Re: **LETTER OF TRANSMITTAL
ROOMS TO GO STORE EXPANSION AND REMODEL**
18722 South Dixie Highway
Cutler Bay, FL 33157
ADDENDUM #3

ADDENDUM NO. THREE

FLOOR PLAN
A1.0

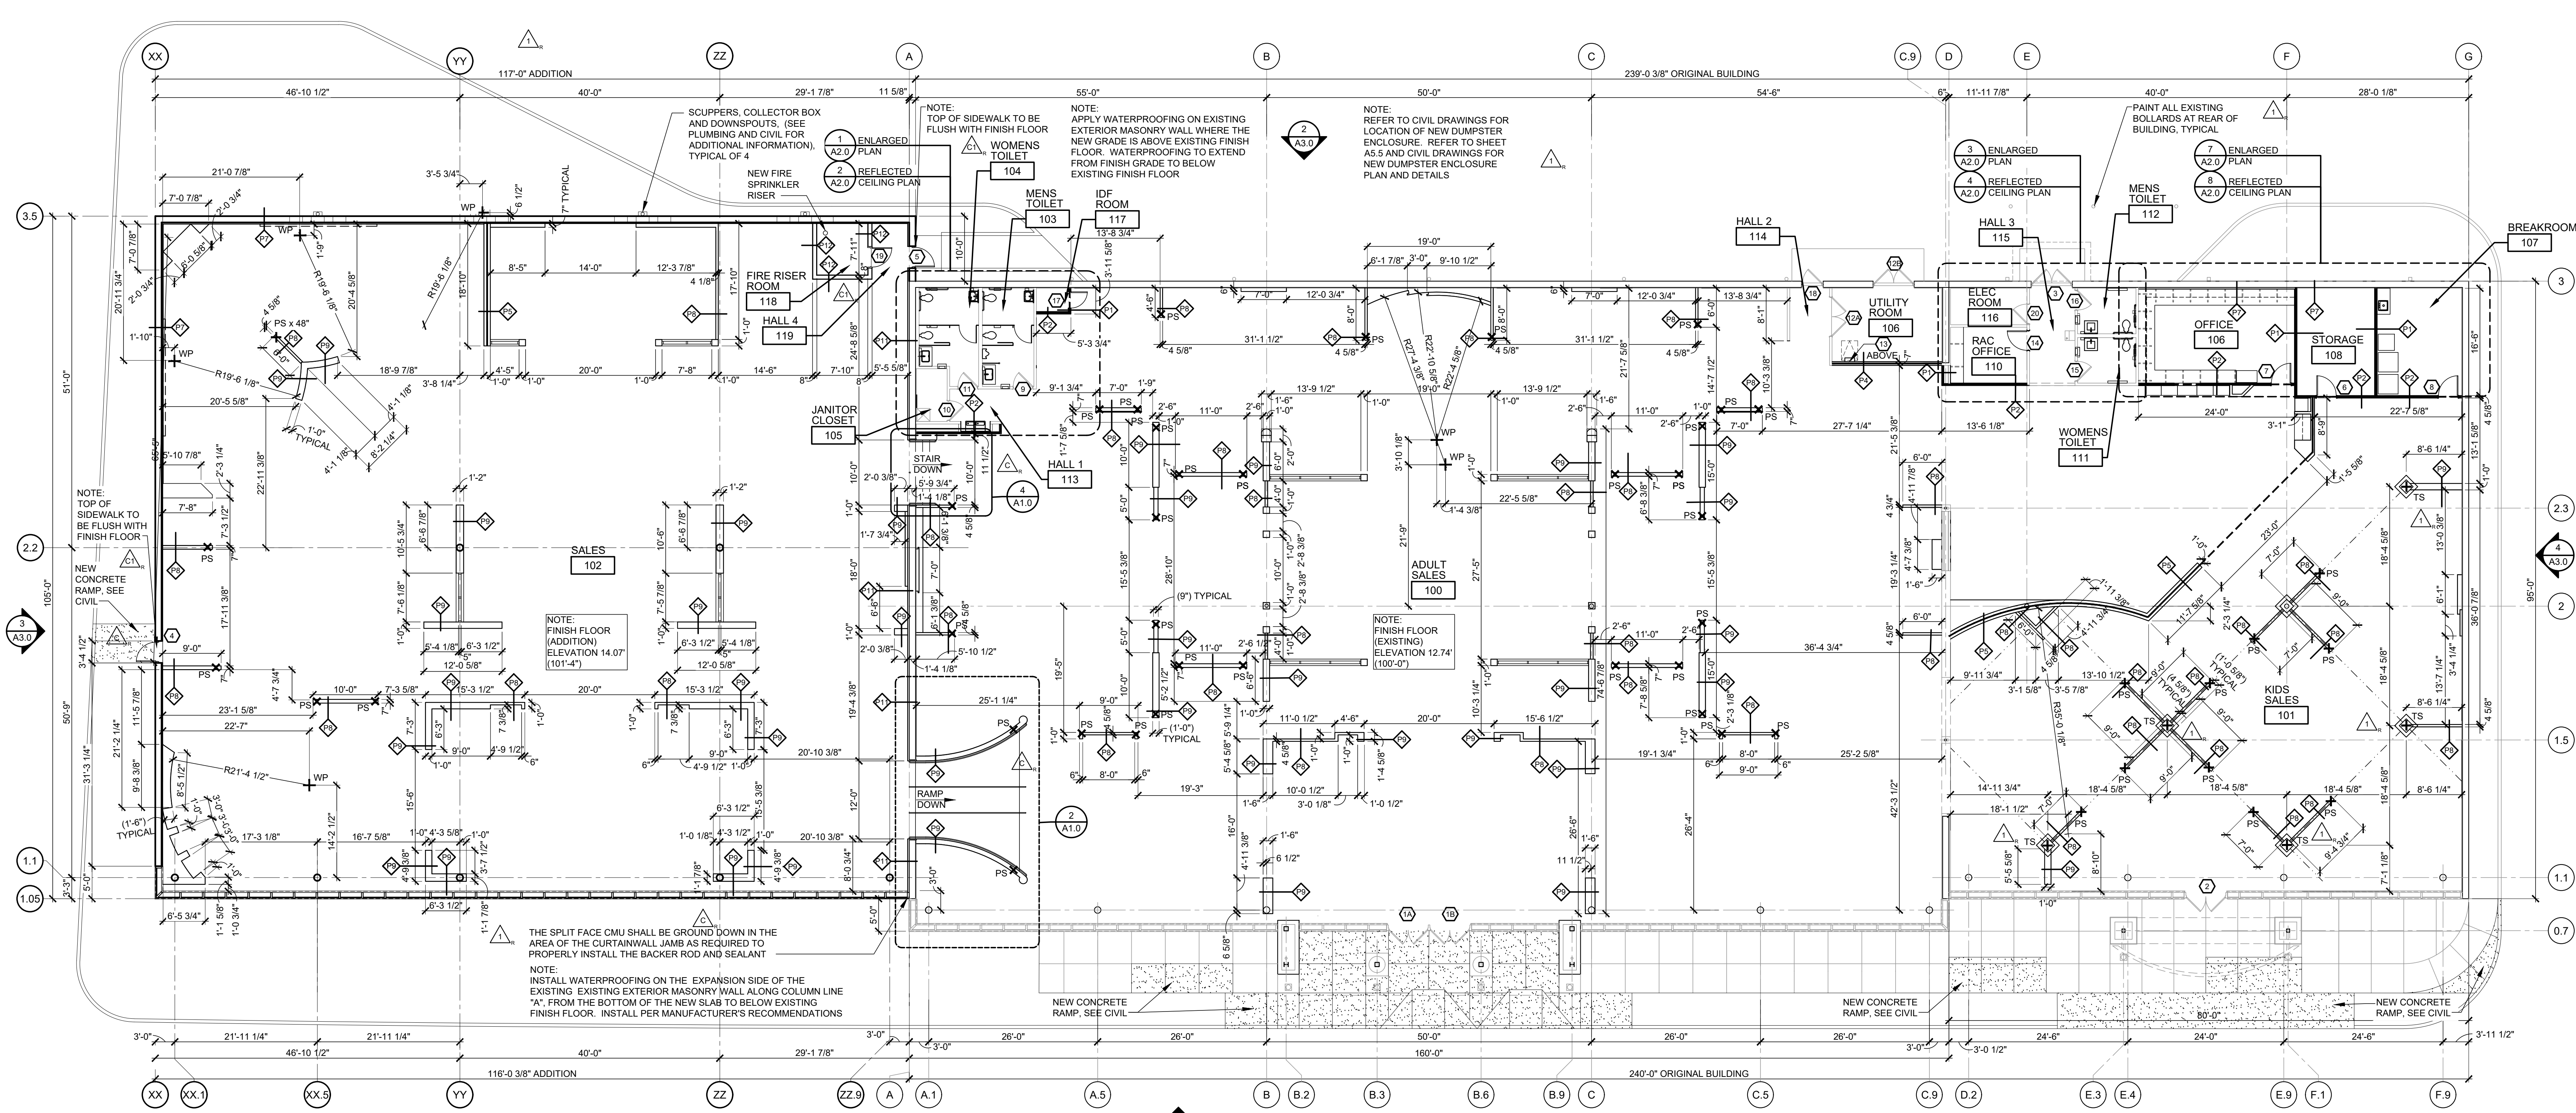
1. Sheet A1.0 – Revision No. 2: Revised rail color to white on sections 3 and 5.
2. Sheet A1.1 – Revision No. 2: Revised LVT-1 and CPT-1 in the Floor Finish Legend.

ELEVATION "M"
1/4" = 1'-0"

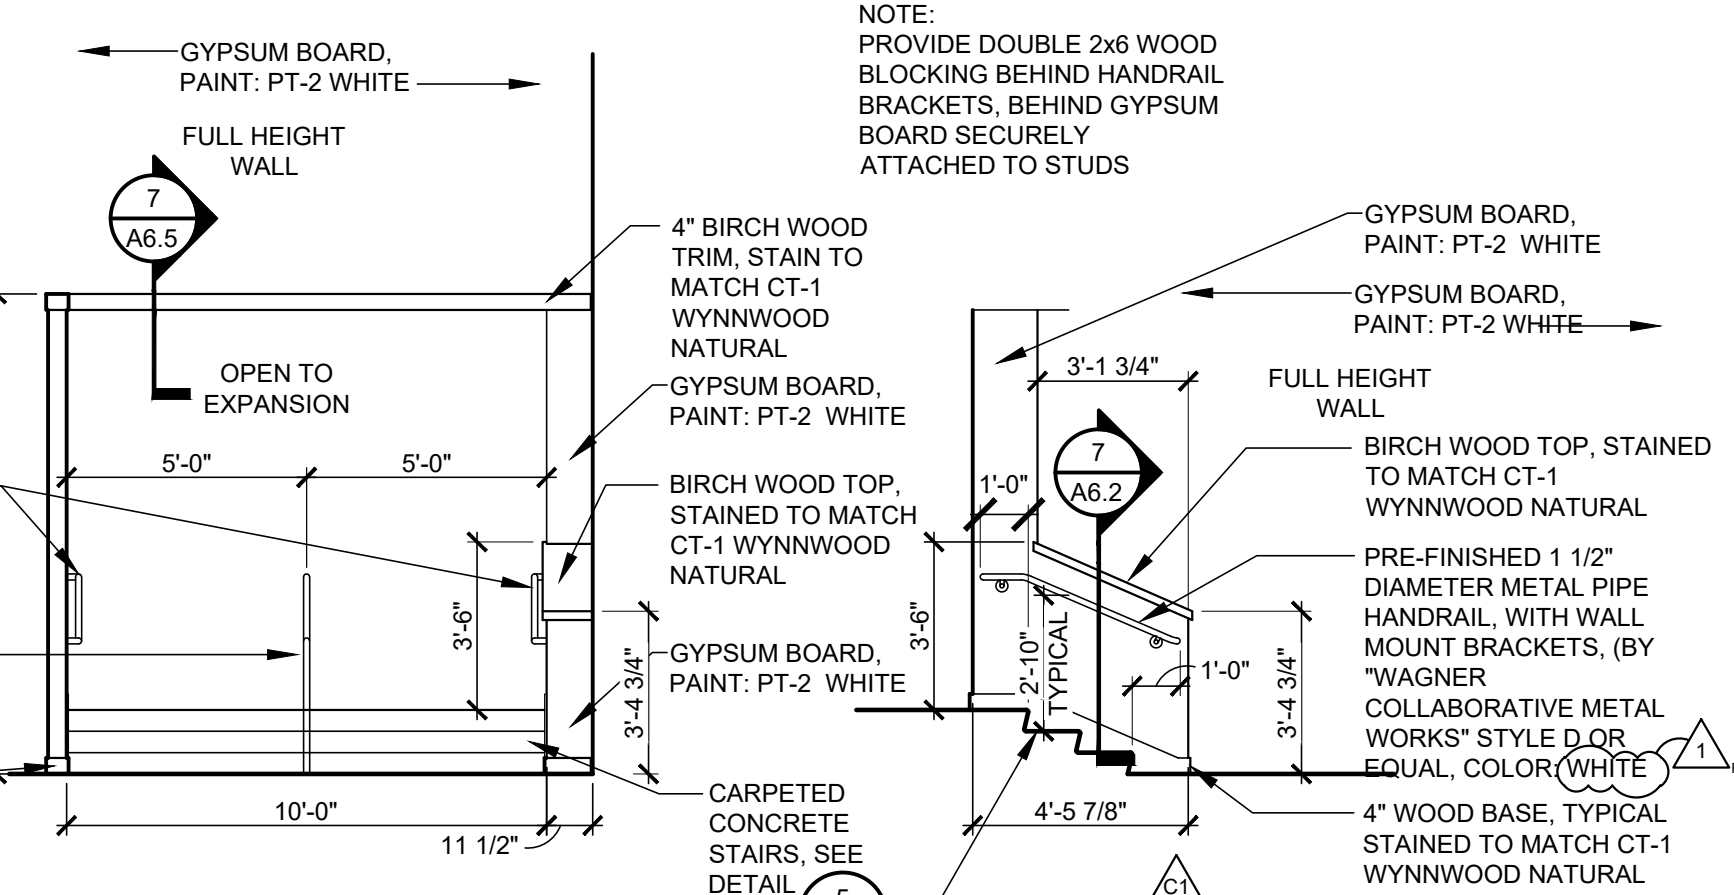
3. Sheet A6.1 – Revision No. 1: Deleted light fixture on Section 5.
4. Sheet A6.2 – Revision No. 1: Revised rail color to white on Elevations M and M1.
5. Sheet A7.0 – Revision No. 1: Deleted wood quarter round from Detail 8.

1 POWER PLAN
E2.0 SCALE: 1/8" = 1'-0"

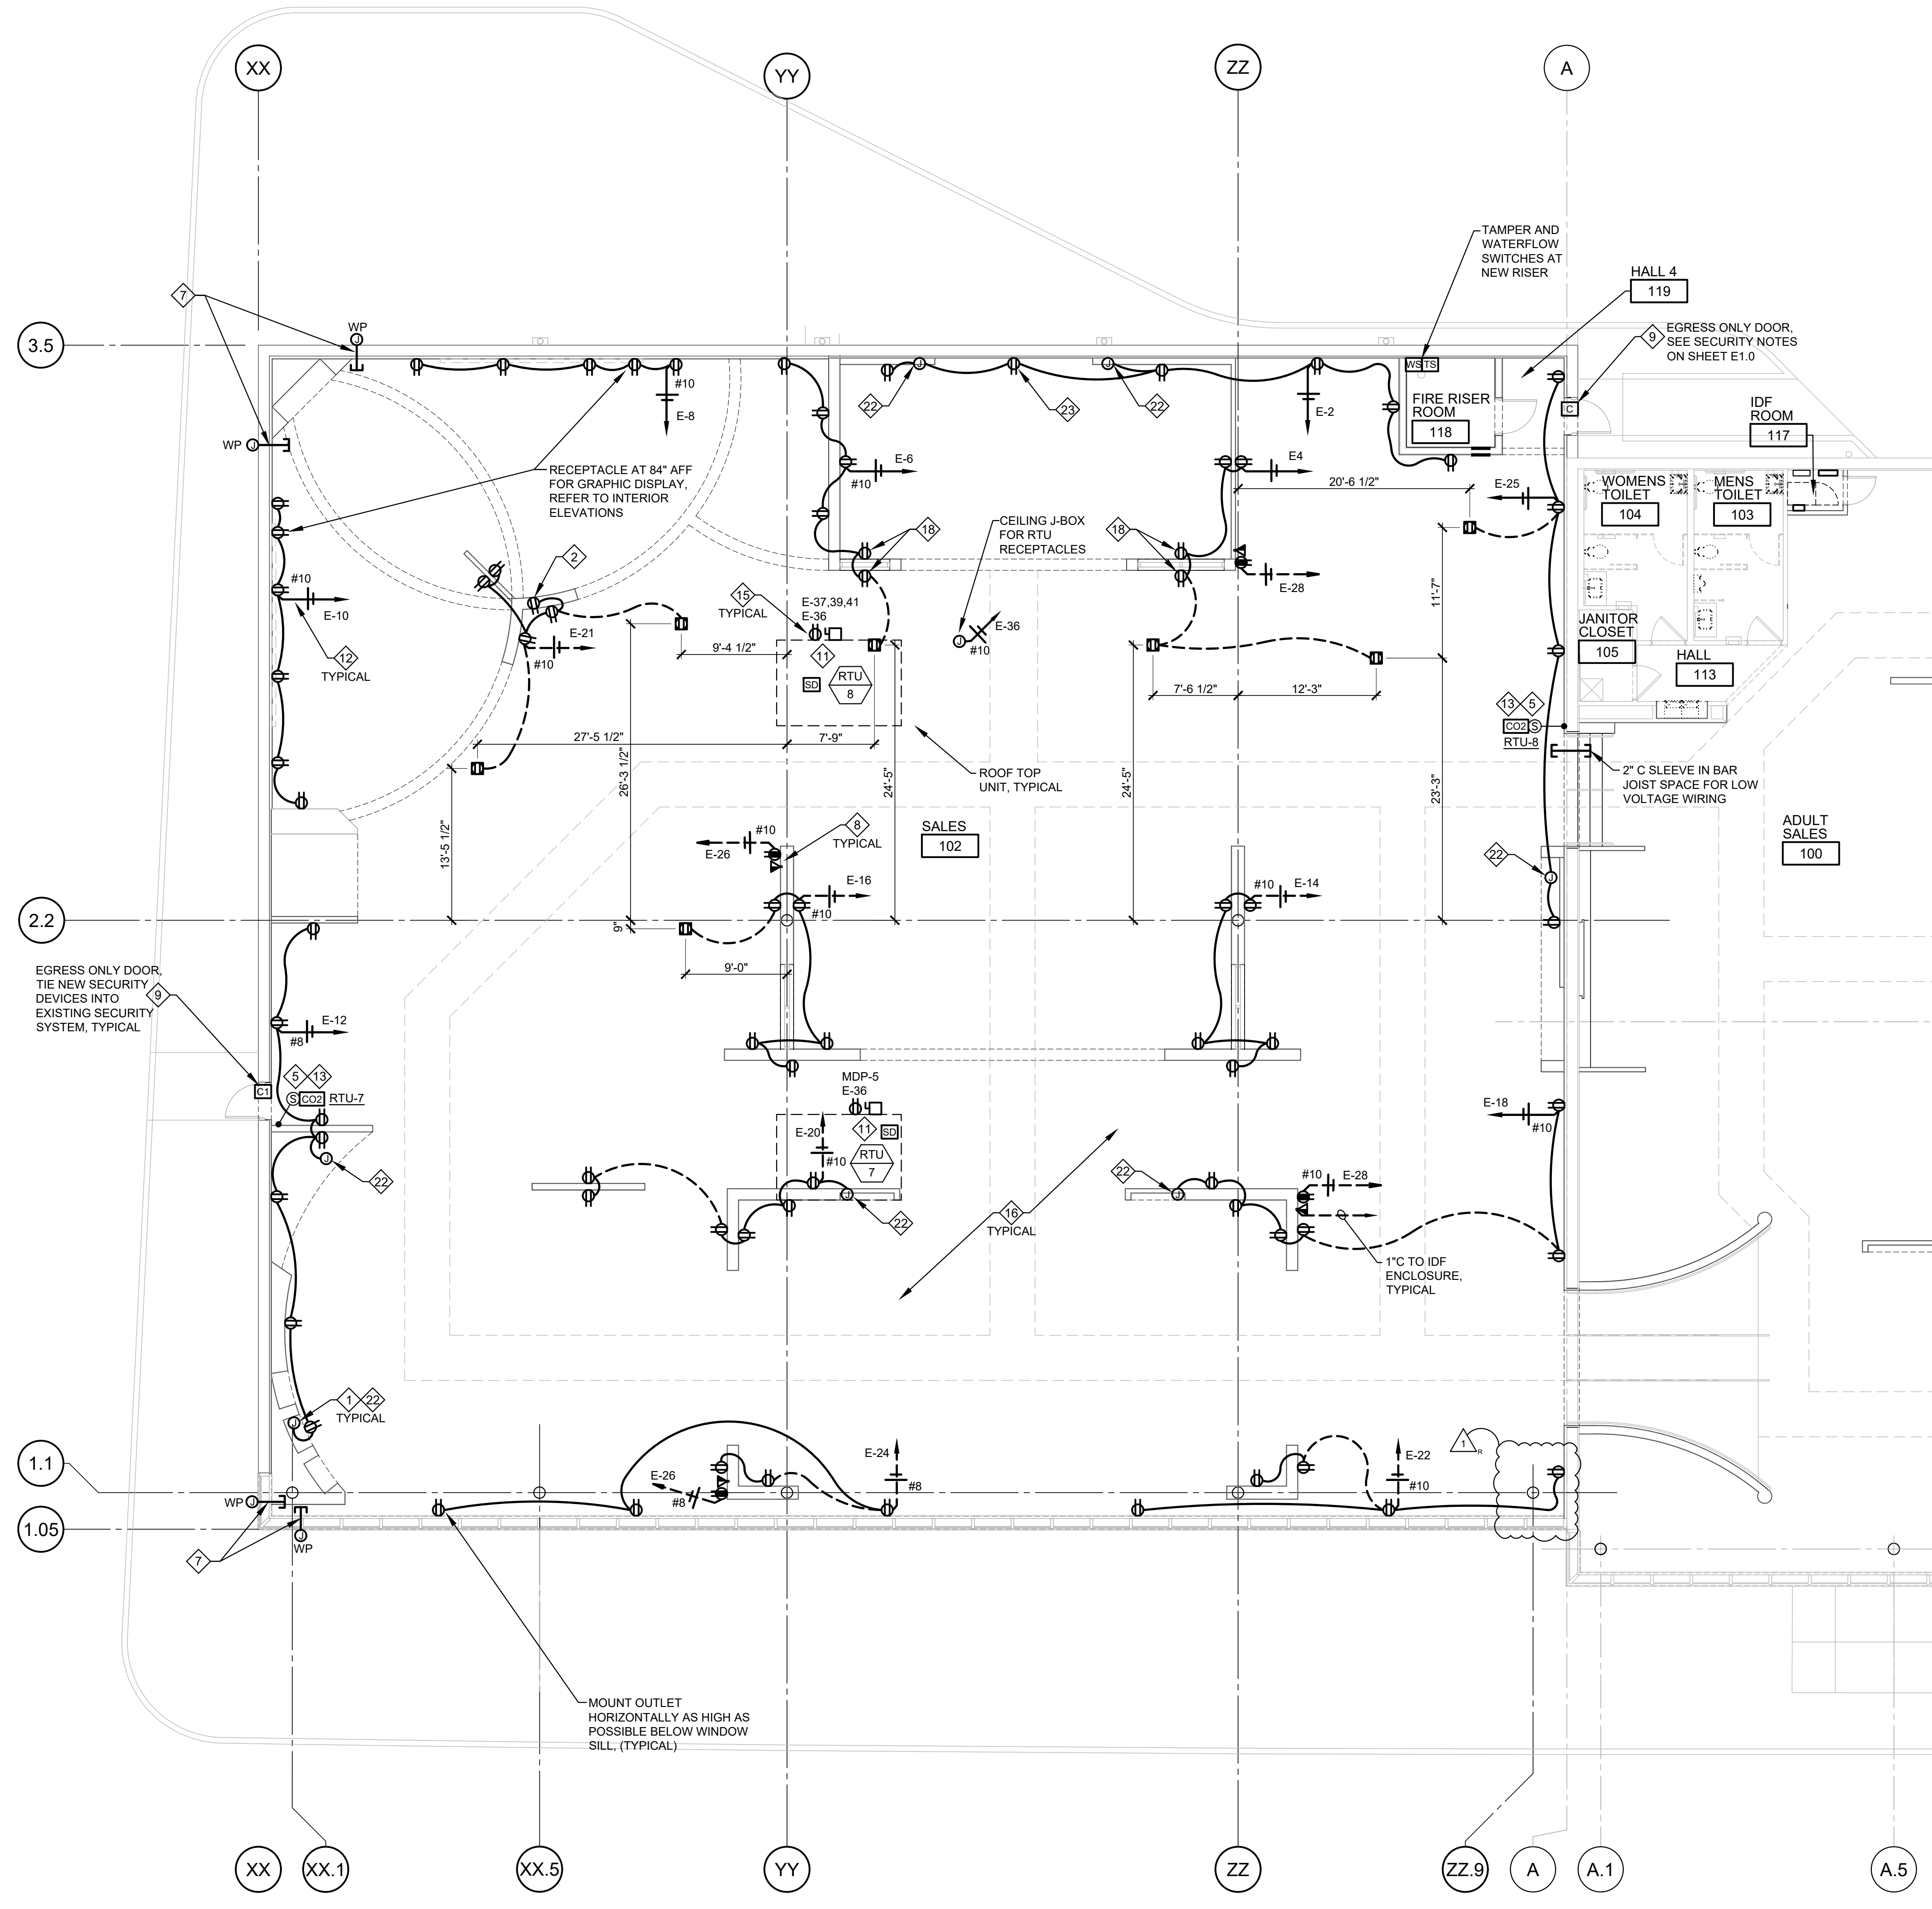
6. Sheet A8.0 – Revision No. 2: Revised LVT-1 and CPT-1 in the Floor Finish Legend.
7. Sheet E2.0 – Revision No. 1: Relocated receptacle at storefront in Sales #102.
